CITY OF ALBUQUERQUE

December 2, 2014

**Re: Abundant Life Gymnasium
Grading and Drainage Plan
Engineer's Stamp Date 11-24-14 (M10D006)**

GRADING AND DRAINAGE PLAN

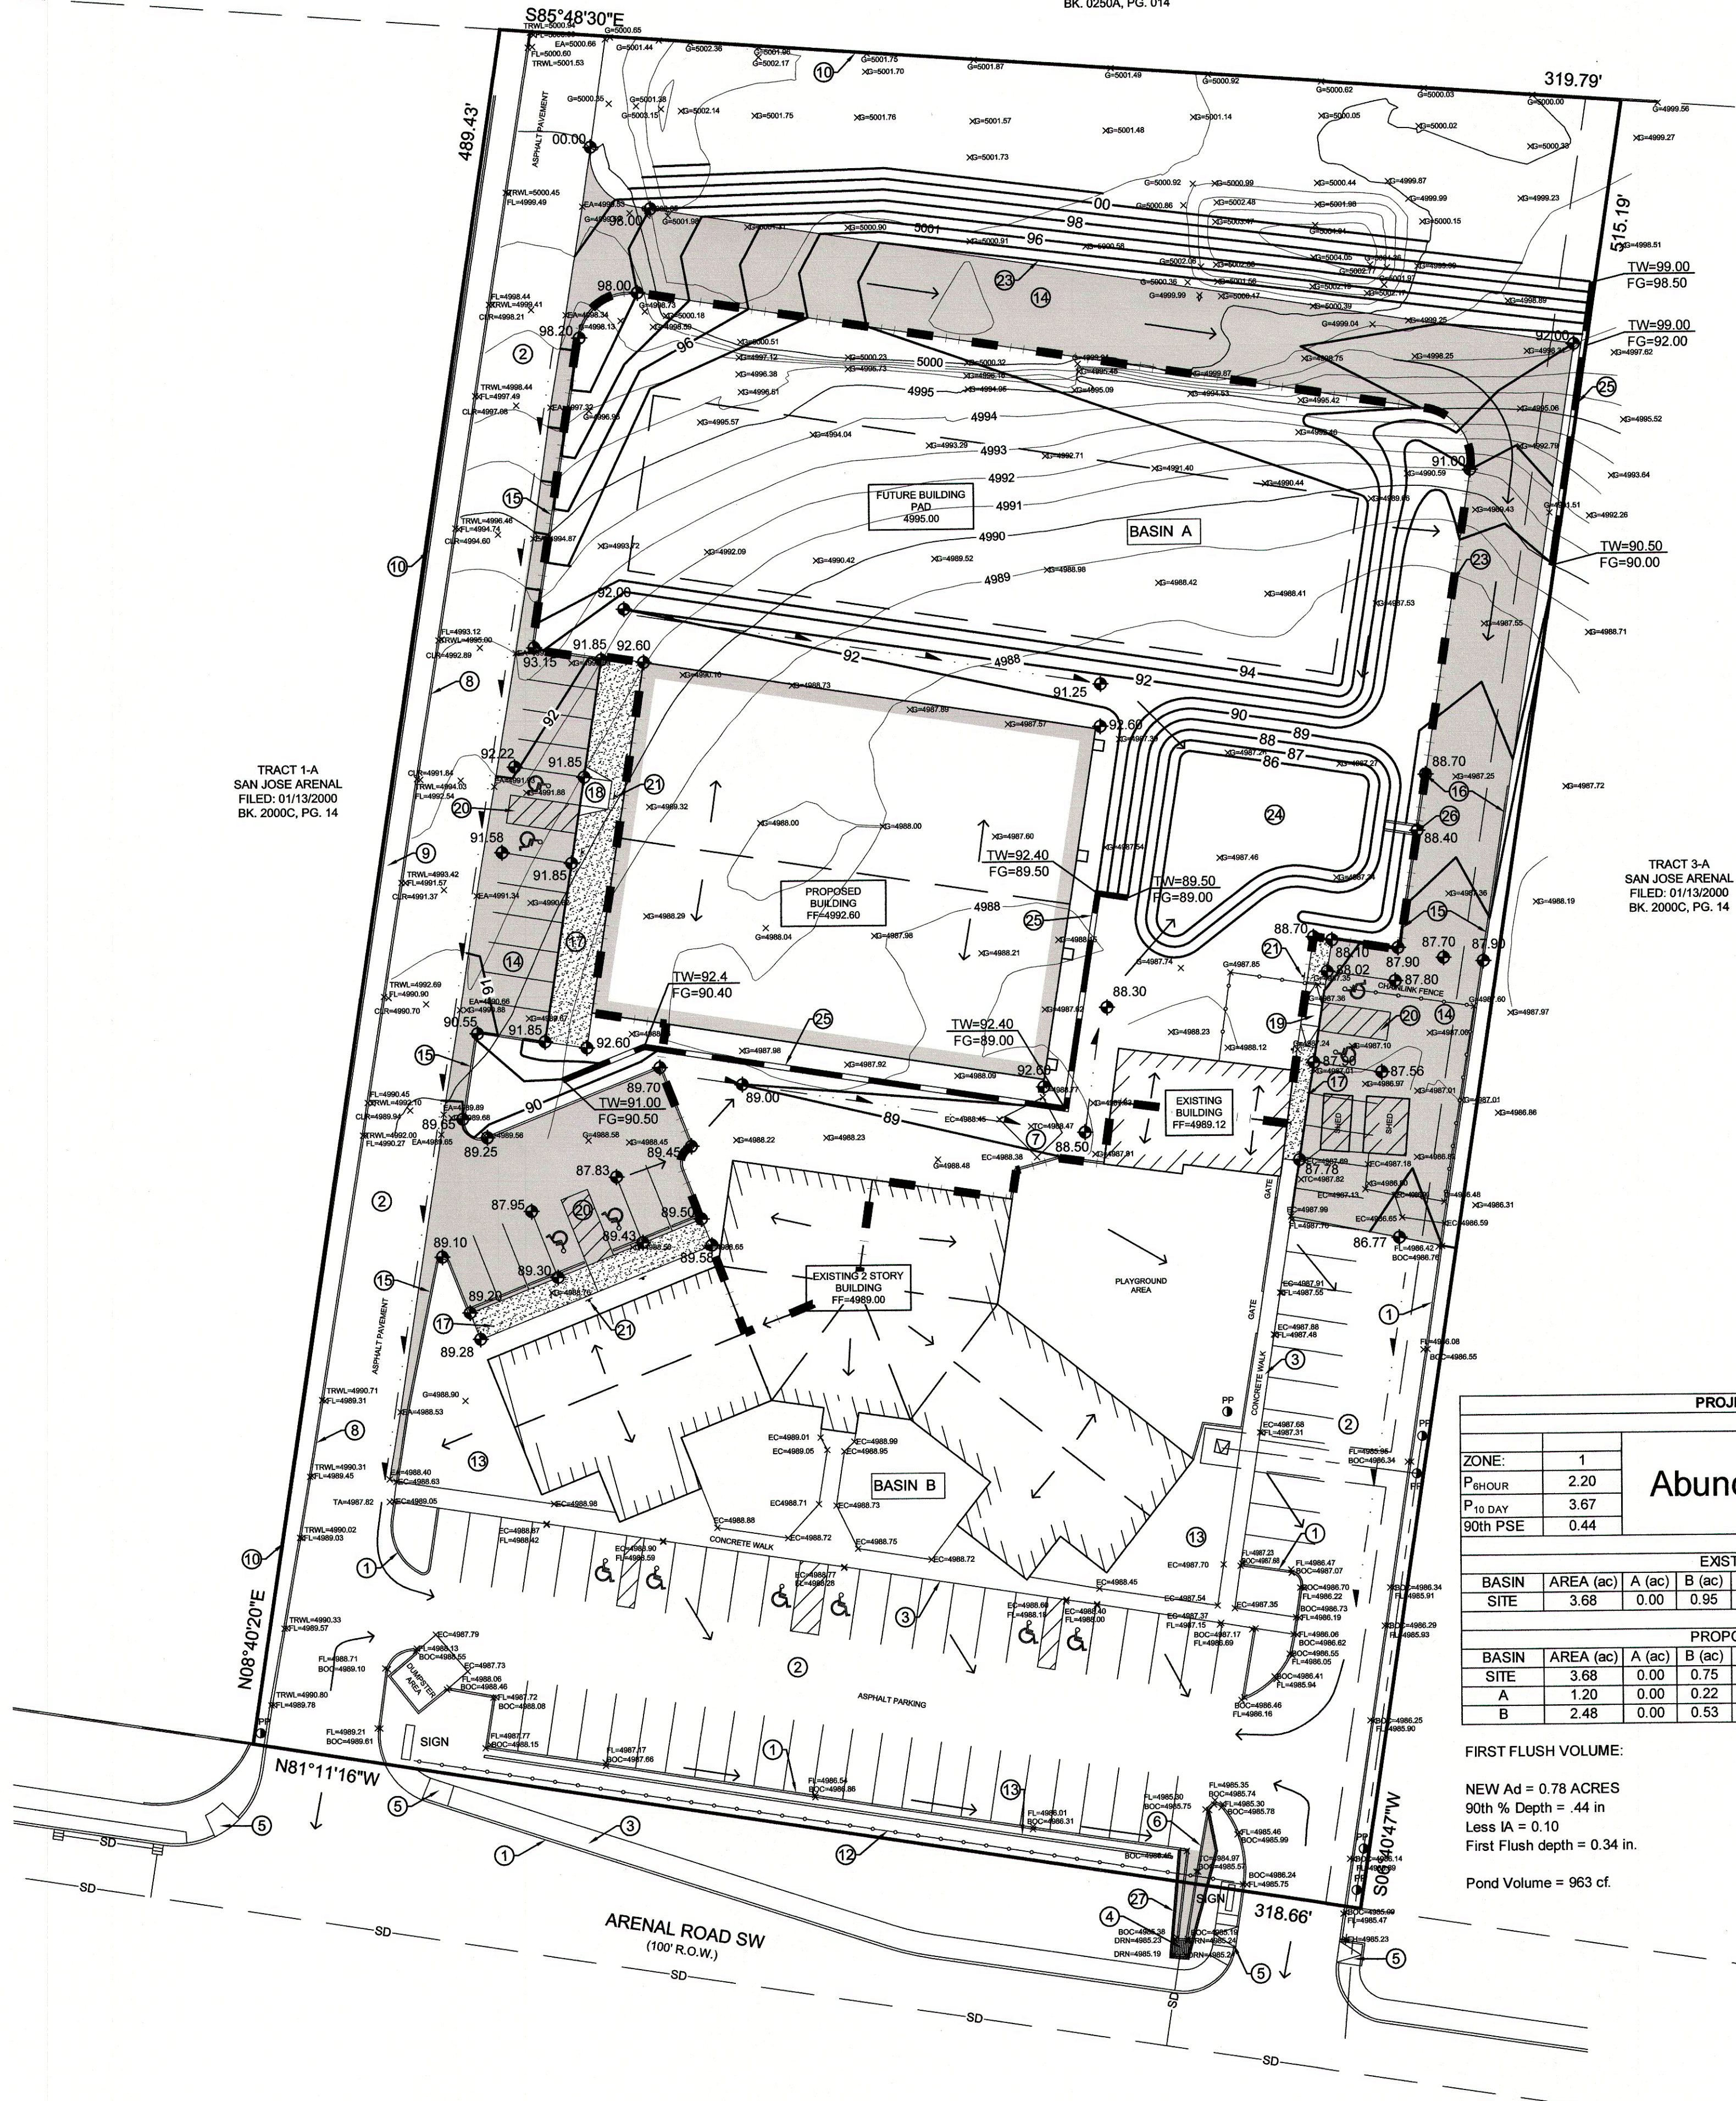
1. Receive approval from Bernalillo County for the amount of flow that is proposed to be discharged to the storm drain in Arenal Road. Although the site is in the City, the storm drain is not City storm drain.

4. The cross slope of the sidewalk adjacent to the proposed building is at 6.25%. Revise to meet ADA standards. Also at the proposed building, signage for the ADA parking is blocking the path at the top of the ramp. Move the ramp to be in front of the ADA striping and move the sign to the edge of the sidewalk. Give spot elevations on the sidewalk next to the ADA striping at the other locations on the site.

5. An existing building is at 89.12, but the proposed sidewalk is at 87.78. Are people using the existing building going to exit onto the sidewalk? If so, adjust the proposed grades. Provide a note that the nearby existing sheds will be removed.

6. The overflow spillway at the beginning of the channel is 88.0, but the end of the channel is 88.40 which is higher. Revise the spot elevations.
7. Provide more spot elevations for the swale on the east in the existing parking. Will storm water be able to drain out of that area?

8. Keyed note 13 is shown in two locations near the existing building but no wall is shown. What should be there; a wall or a different note?

DRAINAGE CHANNEL DETAIL
NTS

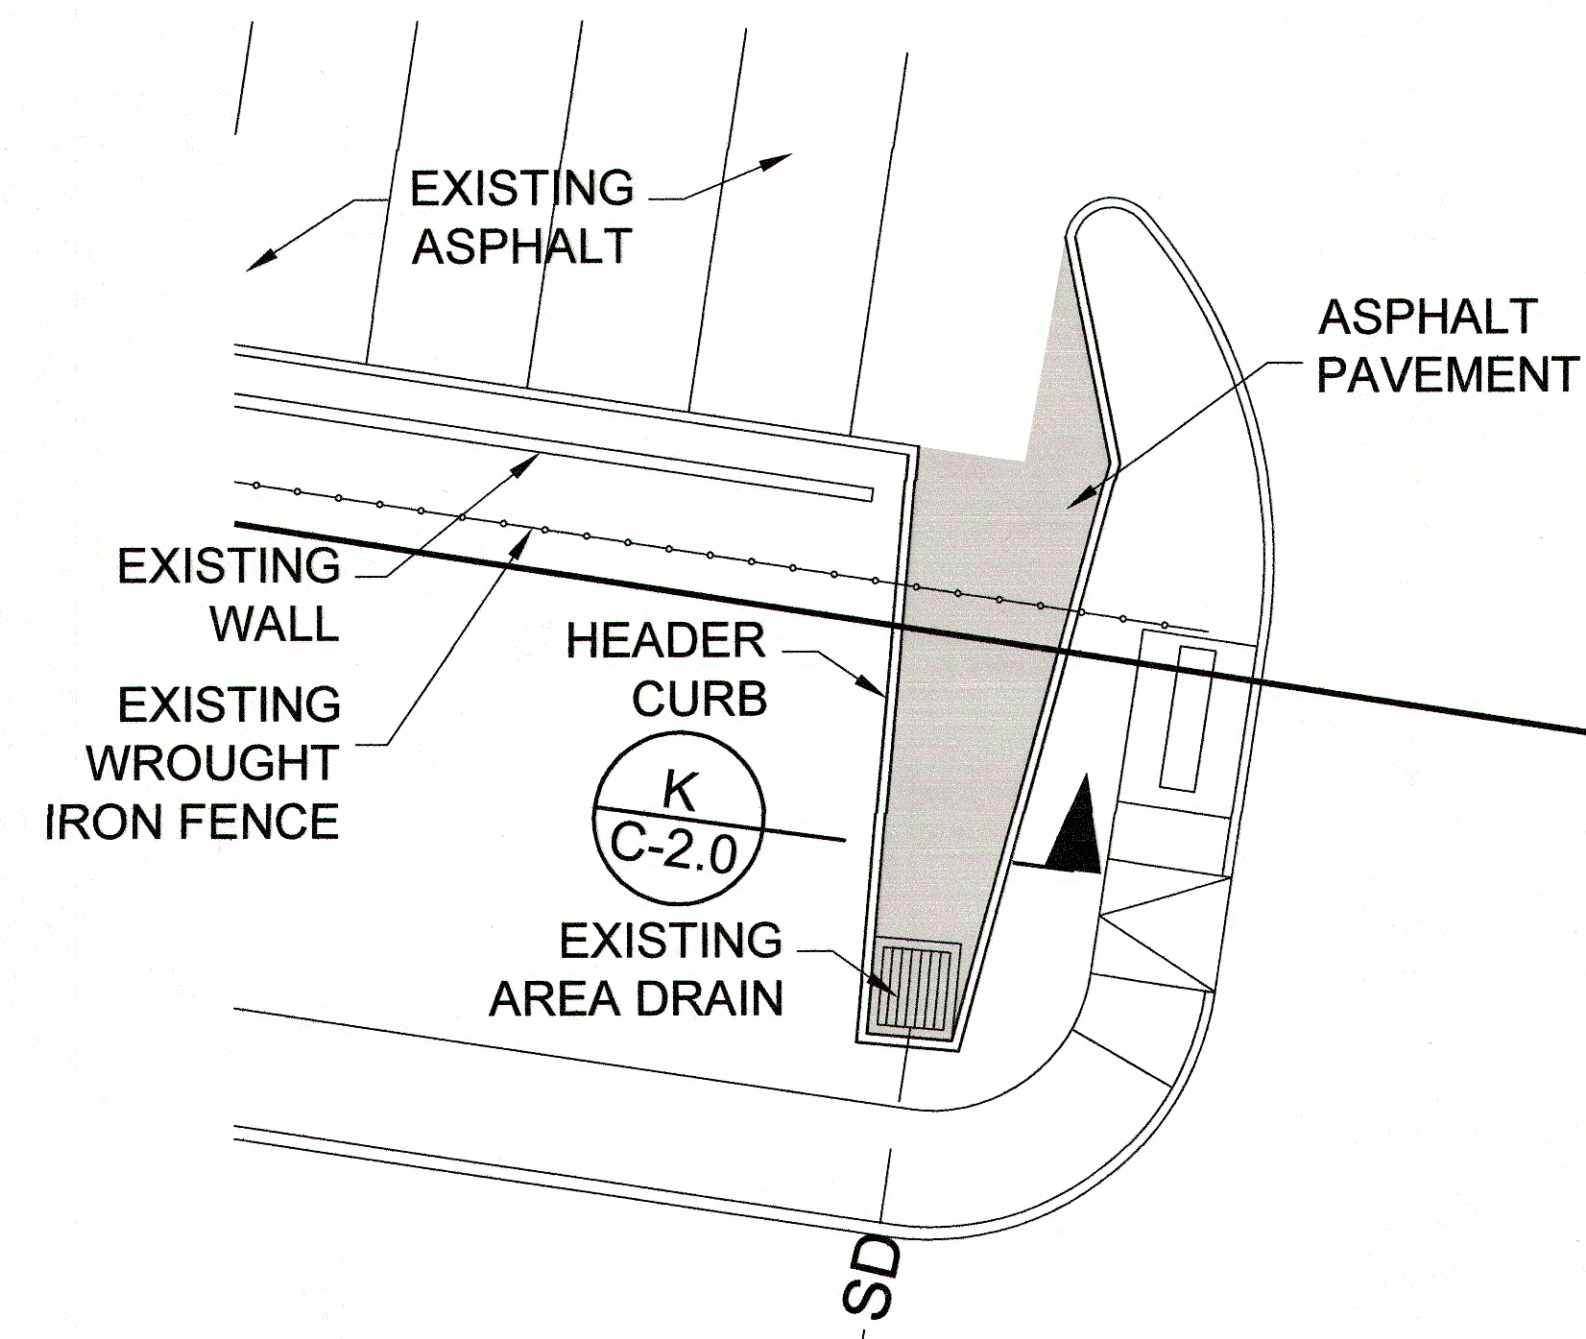
2. When requesting SO-19 approval, provide two sets of paper copies of the plans.
3. For Detail J/C2.0, what are the various width and length dimensions of the channel?
